## ADDENDUM NO. 3

Project Name: Landfill Household Hazardous Waste and Recycling Transfer Facility

Bid Number: 2022011

**REPLACE Sheets S-200, S-300, S-301, S-400** with Revised Sheets (A set of revised structural sheets with callouts indicating the change, and a set of full structural plans are provided)

FOUNDATION AND SLAB ON GRADE PLAN  
SCALE: 3/32"=1'-0"

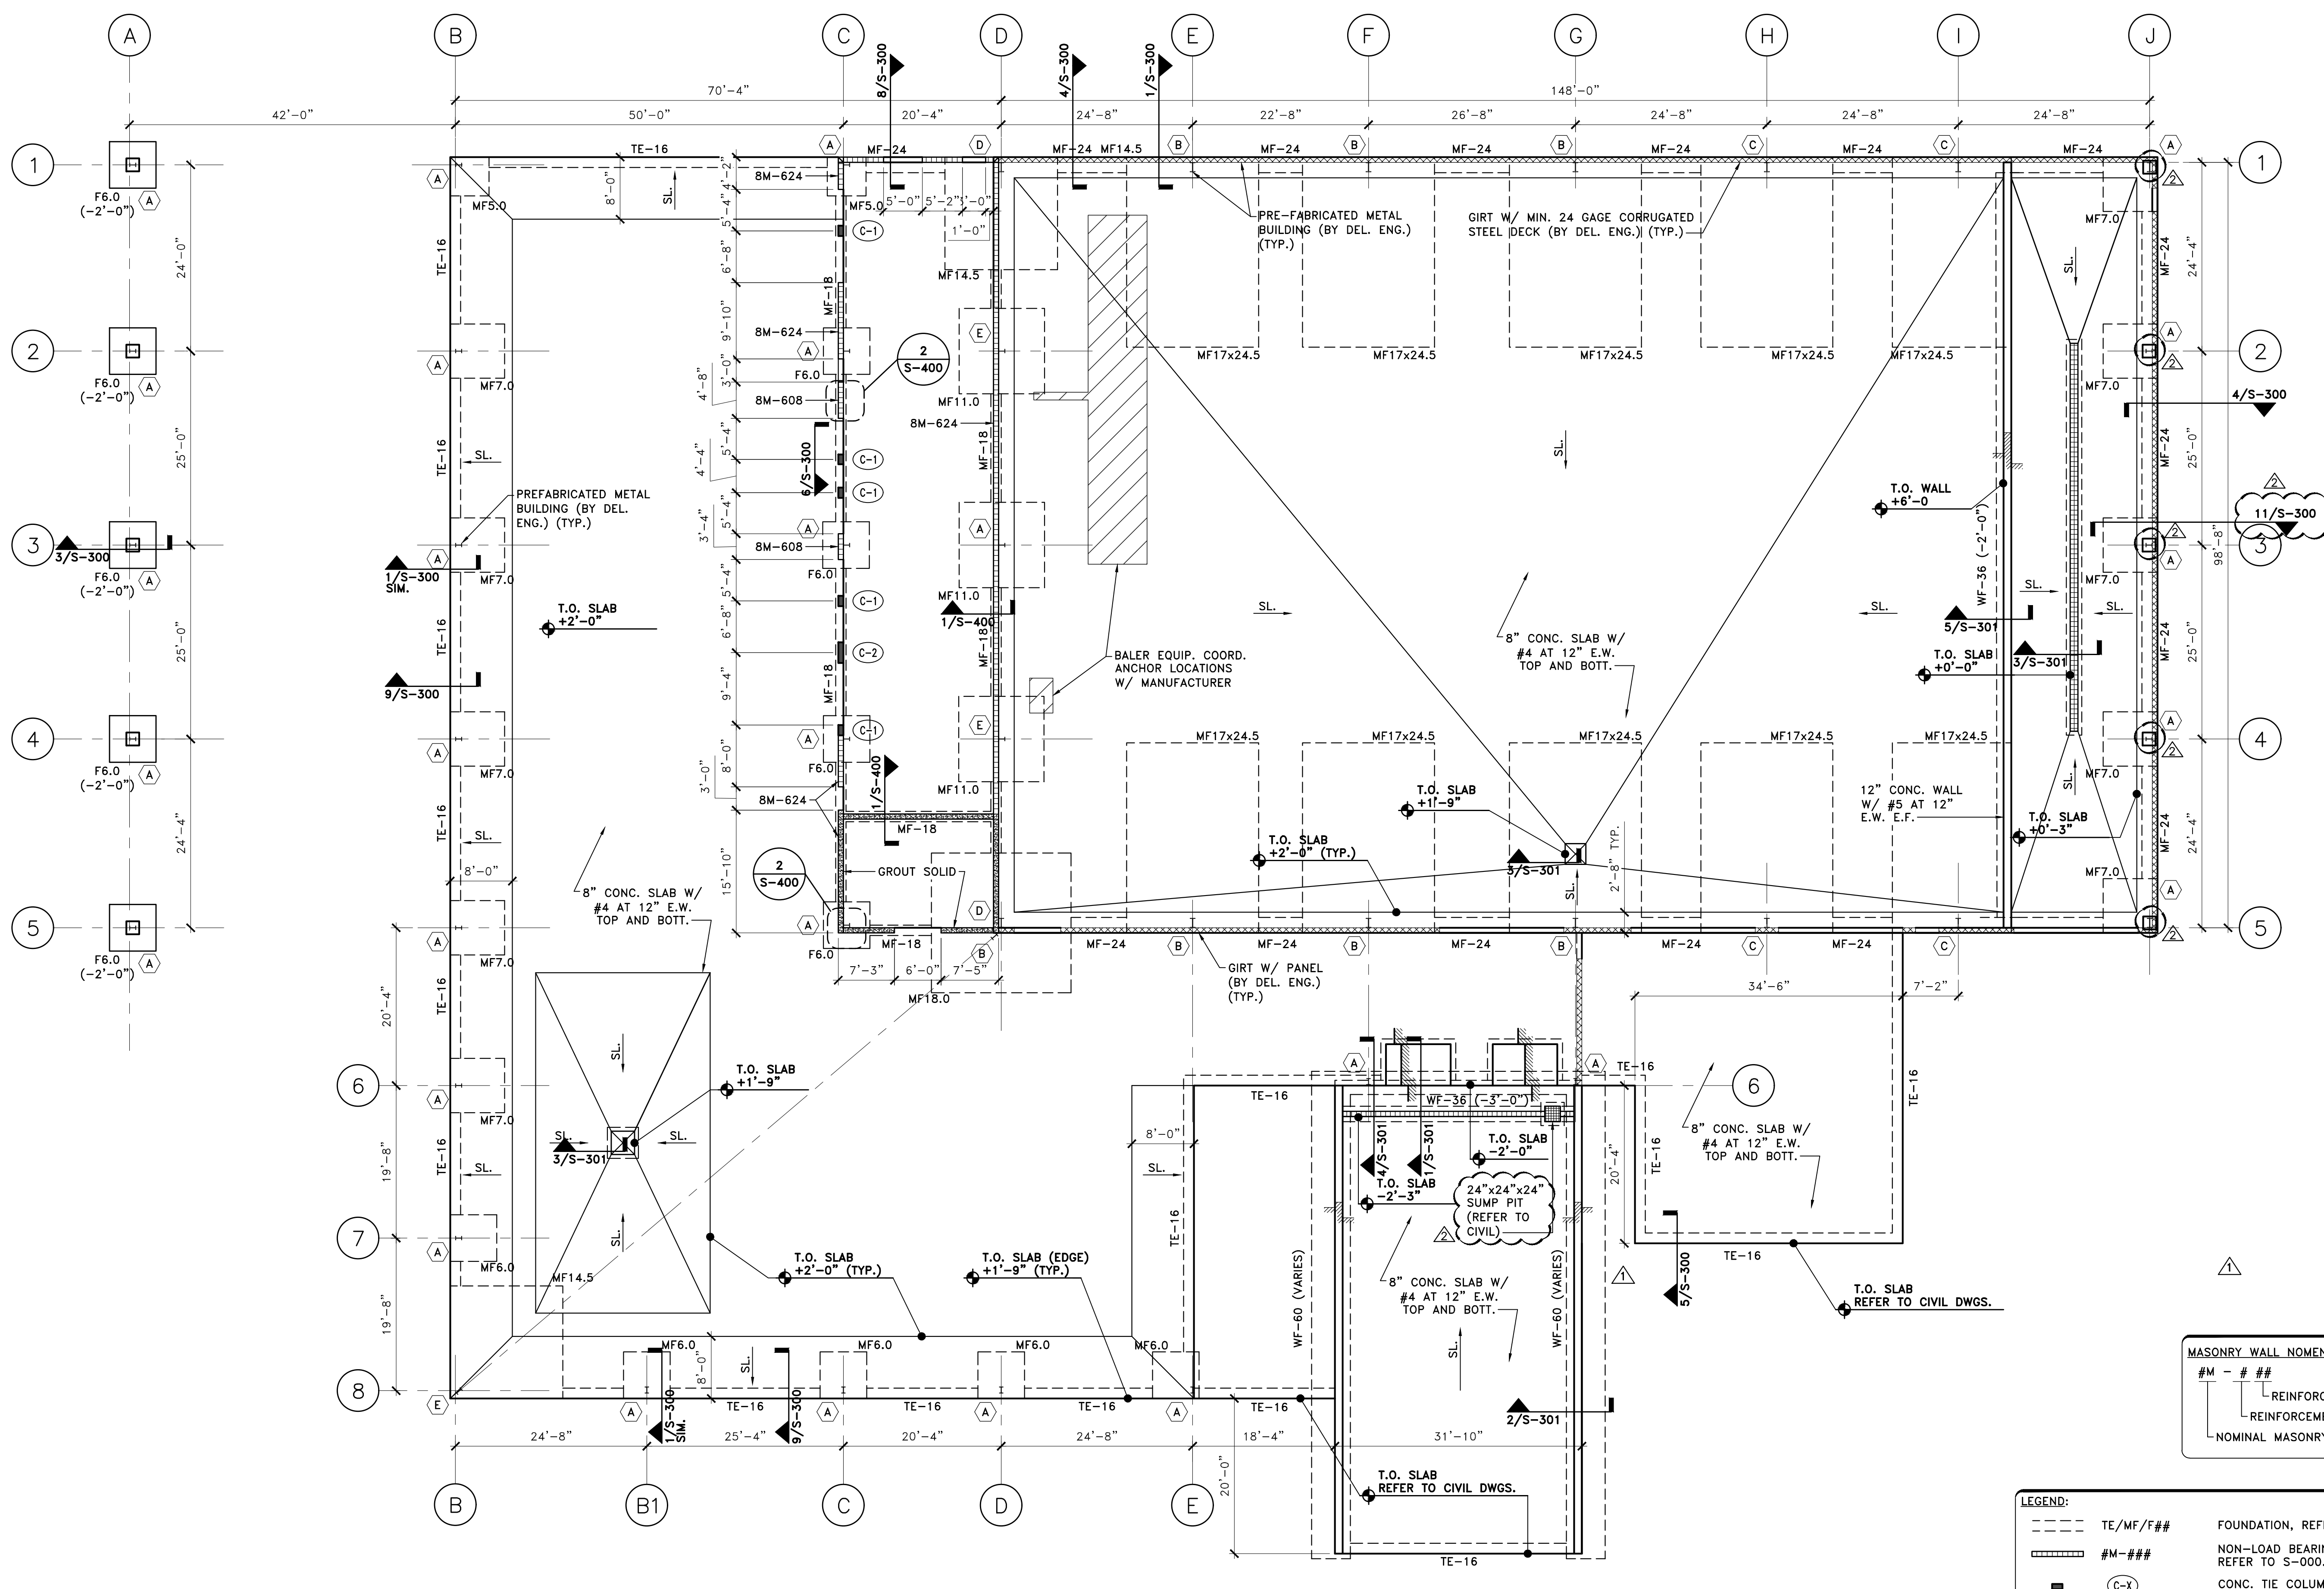
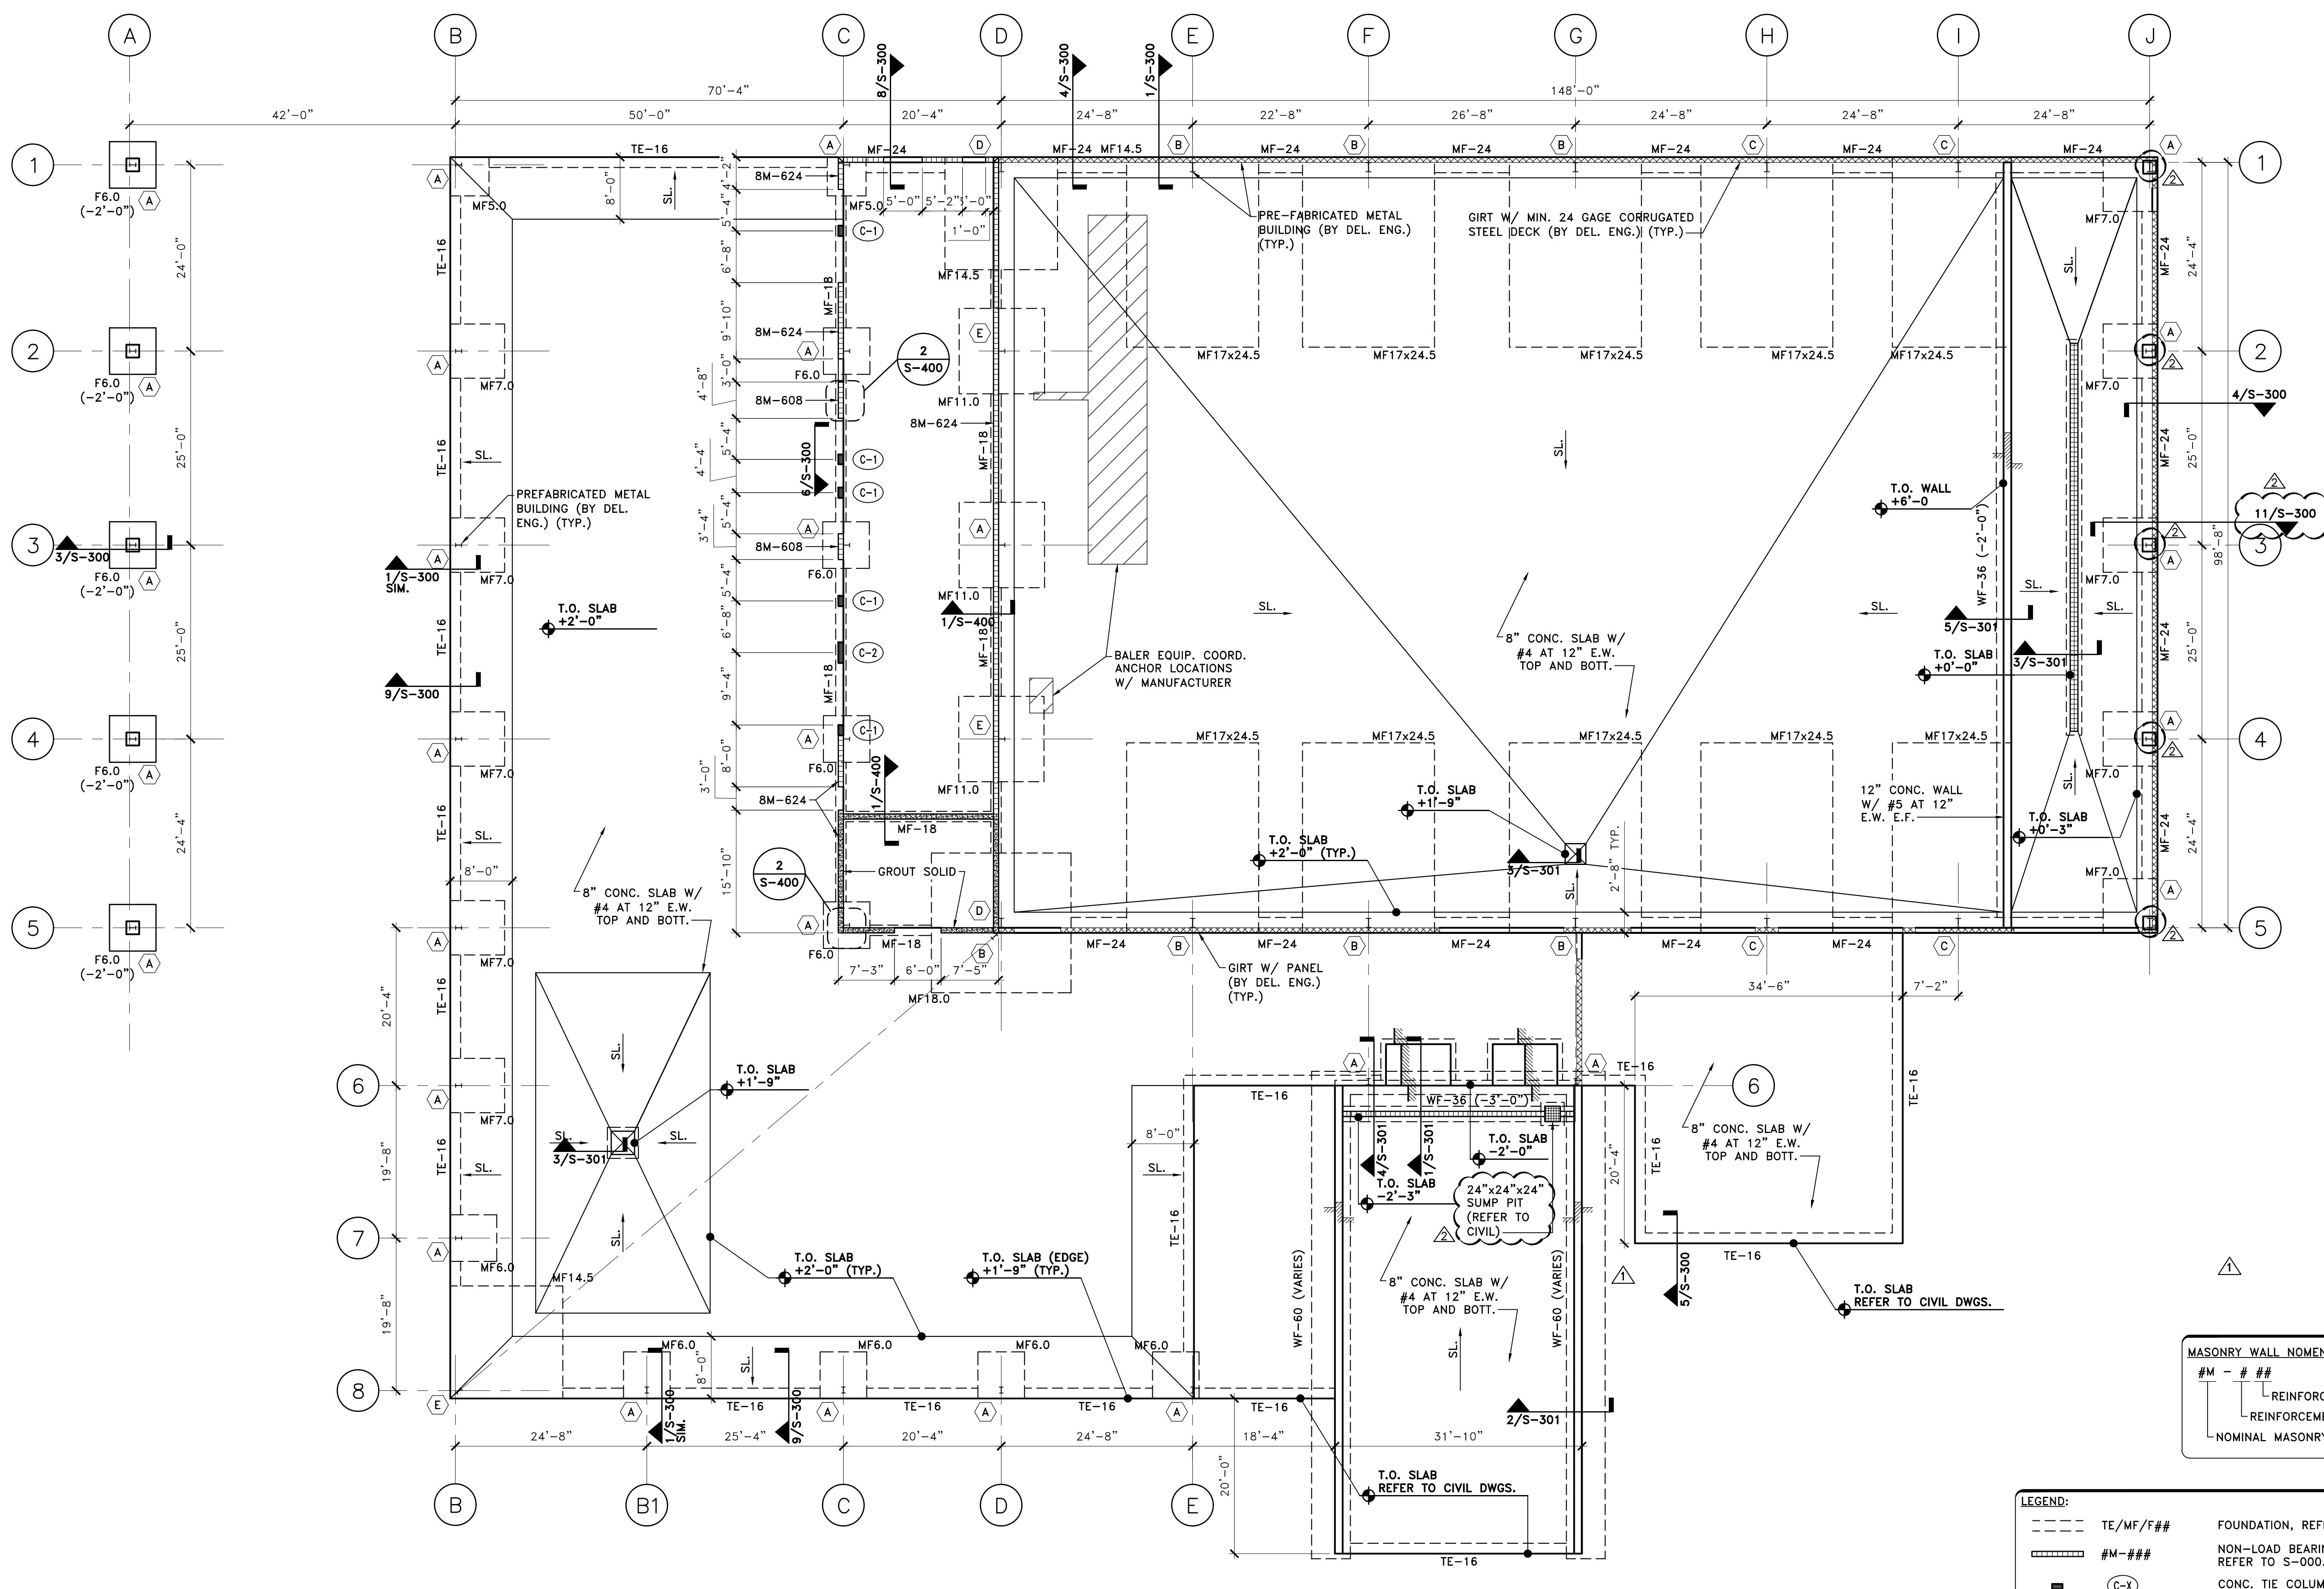
19. On the floor plan, page A101, at the Covered Drop-Off Area, the measurements don't match the foundation plan, page S-200. The foundation plan doesn't look finished either at that area.

**Refer to Sheet S-200 Revision 1.**
